NS-TMA-2285

SUBJECT: Responses to Questions on WCAP-9226, "Reactor Core Response to Excessive Secondary Steam Releases"

WCAP-9226 "REACTOR CORE RESPONSE TO EXCESSIVE SECONDARY STEAM RELEASES"
 RESPONSE TO FIRST ROUND QUESTIONS - STATUS SUMMARY

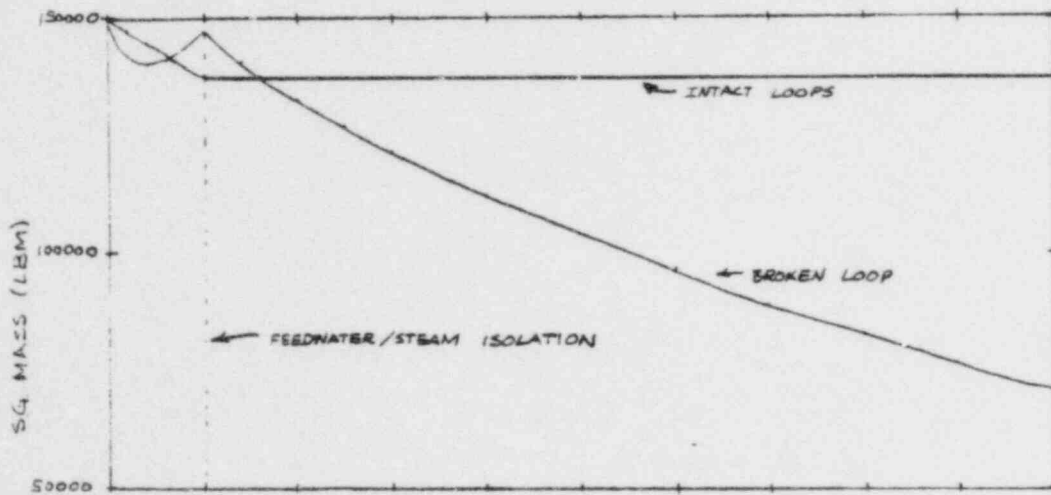
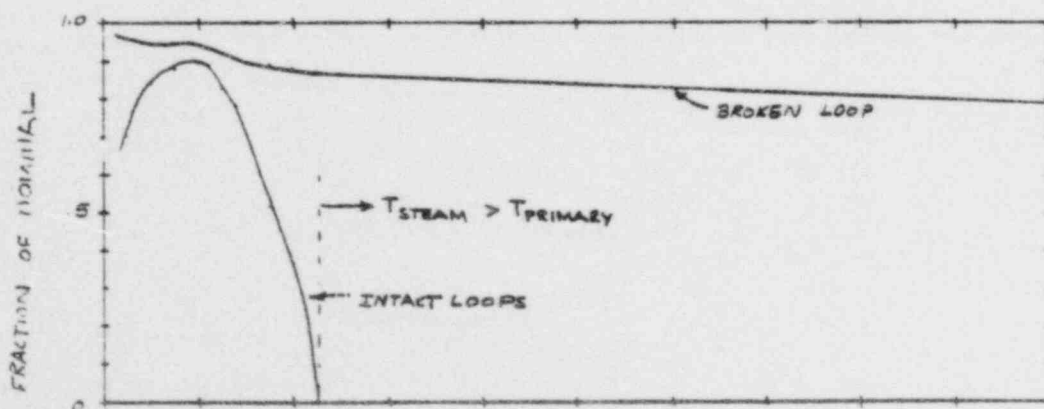
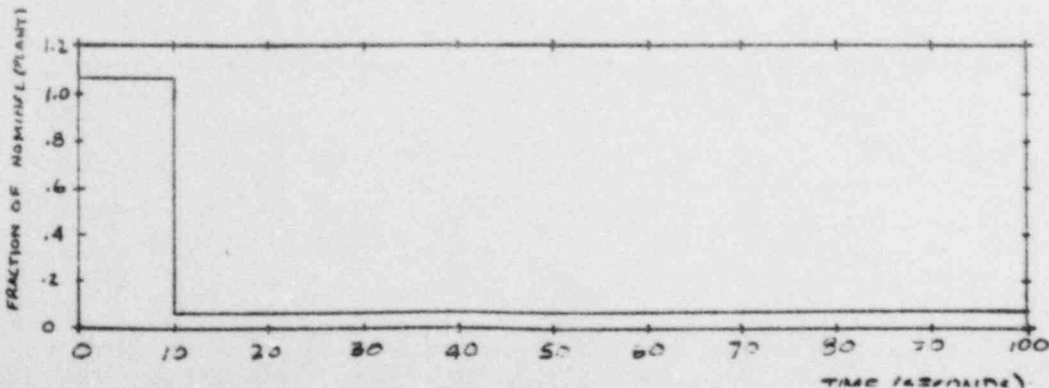
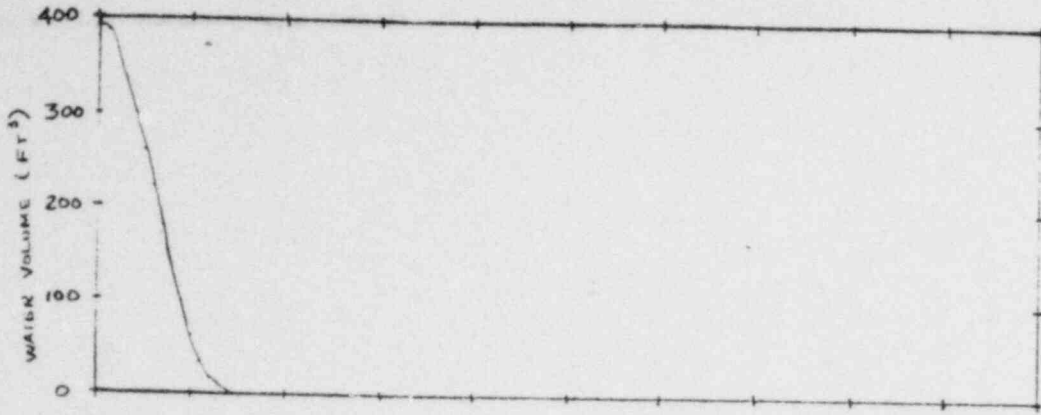
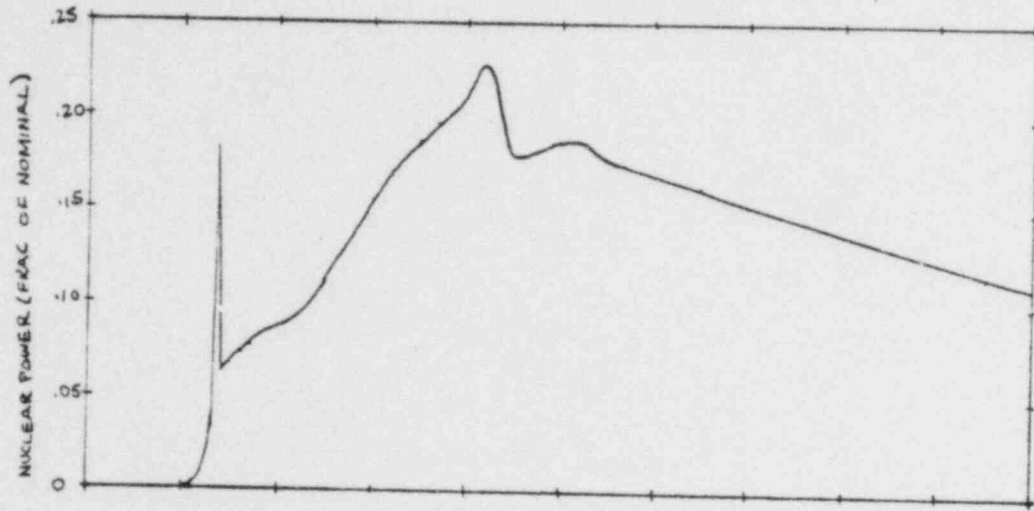
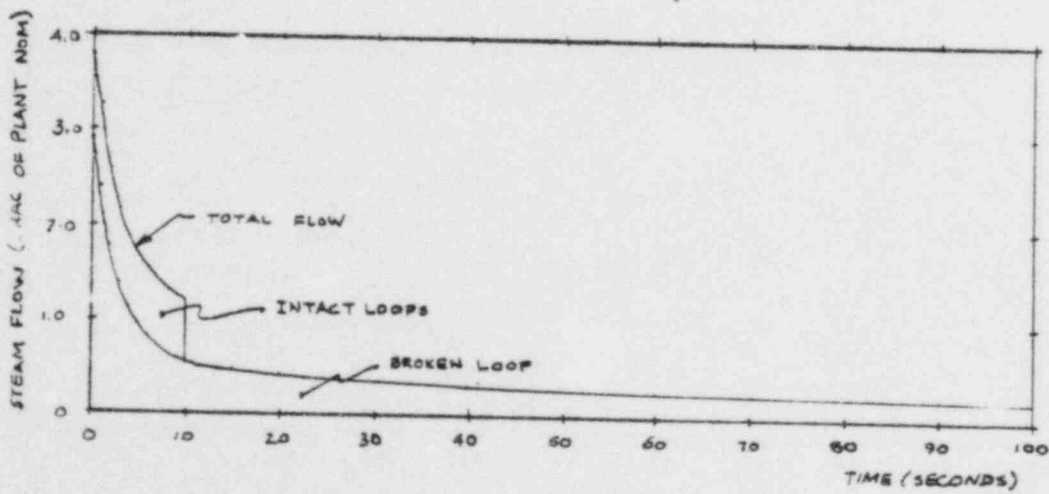
Q) 212.9 WCAP-9226 should provide time-dependent graphs of the following parameters for the limiting case at hot shutdown and the limiting case at full power (in addition to those provided)

- (1) steam generator pressure
- (2) steam generator level
- (3) steam generator UA used in analysis
- (4) break discharge flow
- (5) steam generator fluid temperature
- (6) fuel and cladding temperatures
- (7) steamline feedwater flow rates
- (8) pressurizer water level
- (9) reactor power

All graphs must be scaled and labeled to permit evaluation.

For the limiting breaks at full power the only graphs that are not provided are the steam generator level, steam generator UA and fuel/cladding temperature. The fuel and cladding temperature can be easily inferred from coolant temperature since the DNB design basis is met. The additional steam generator graph would only show that the level is above the top of the tubes and there is full UA prior to trip.

Pressurized Water Reactor Schematic Diagram

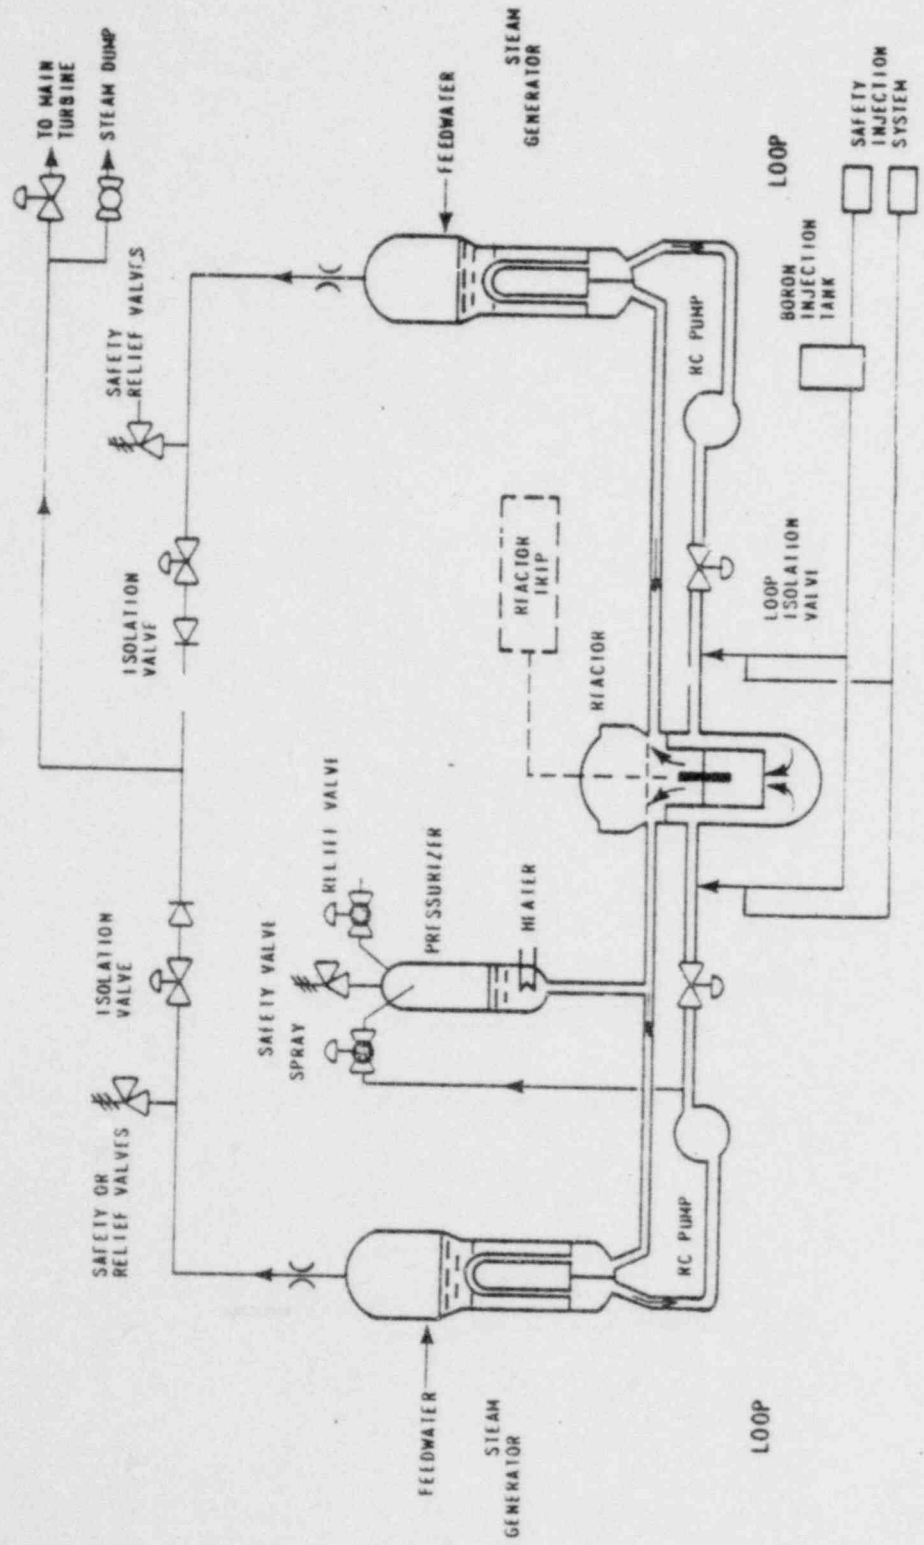
Q) 222.1 Provide a detailed flow diagram for the primary and secondary systems identifying all the components considered in the steam line break accident analysis.

A flow diagram is attached, showing the relevant components and systems considered in the steamline break analysis. Specifically these include:

- Reactor Coolant Piping (multi-loop)
- Steam Generators
- Reactor Vessel
- Reactor Coolant Pump
- Steam flow
 - to turbine
 - to break
- Feedwater flow
 - main feedwater
 - auxiliary feedwater
- Plant Control Systems
 - CVCS
 - pressurizer pressure control
 - automatic control rod control
 - turbine bypass (steam dump)
 - steam generator relief valves
- Plant Protection and Engineered Safeguards Features
 - Reactor trip
 - Turbine trip
 - Safety injection system
 - Auxiliary feedwater system
 - Primary (pressurizer) safety valves
 - Secondary safety valves
 - Steamline and feedwater isolation

The assumptions governing the status of these systems are described in WCAP-9226 via parameter sensitivity studies, analyses of single failures and evaluations.
